MEMORANDUM

SUBJECT: EPA Comments on “Assessment of Dam Safety of Coal Combustion Surface Impoundments: City Utilities of Springfield, John Twitty Energy Center (formerly Southwest Power Station), Springfield, Missouri”

DATE: January 16, 2014

Sketch 107

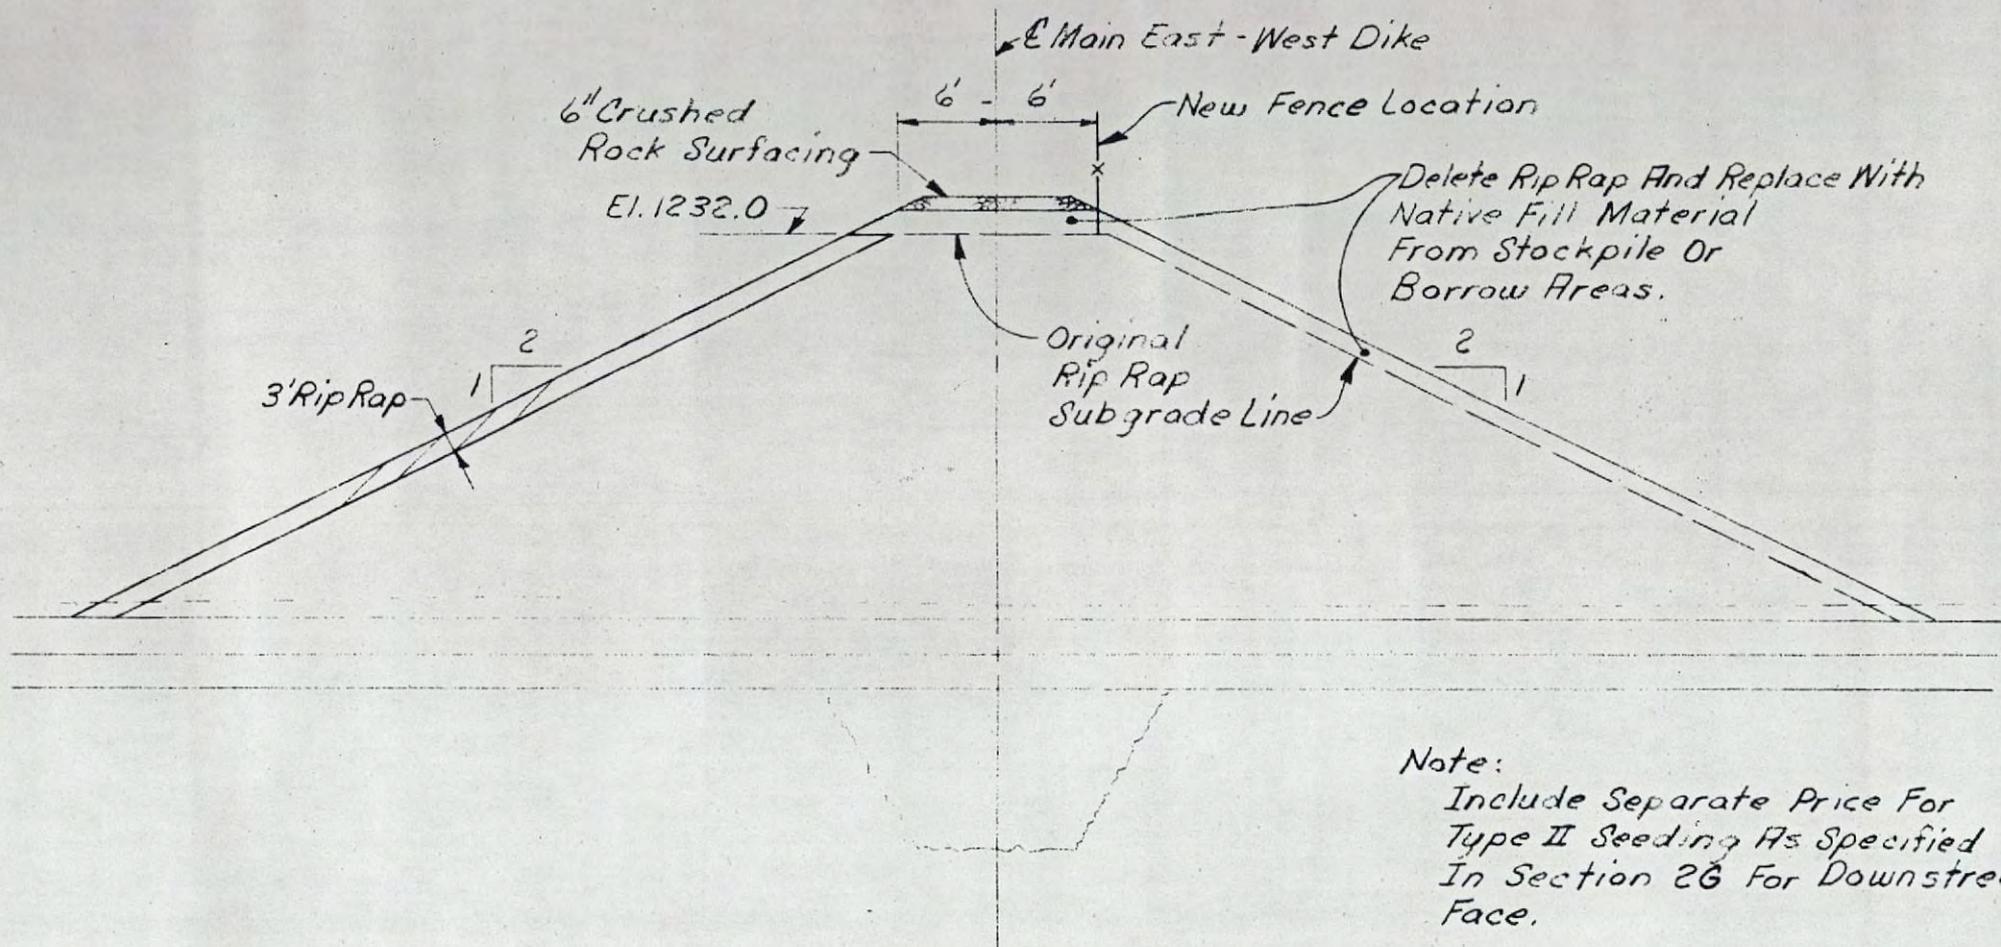
The rip-rap across the top of the north-south dike would be replaced with material as specified for embankment - Section 2D; the rip-rap across the top of the east-west dam and its downstream face would be replaced with native fill material taken from stockpile or borrow areas.
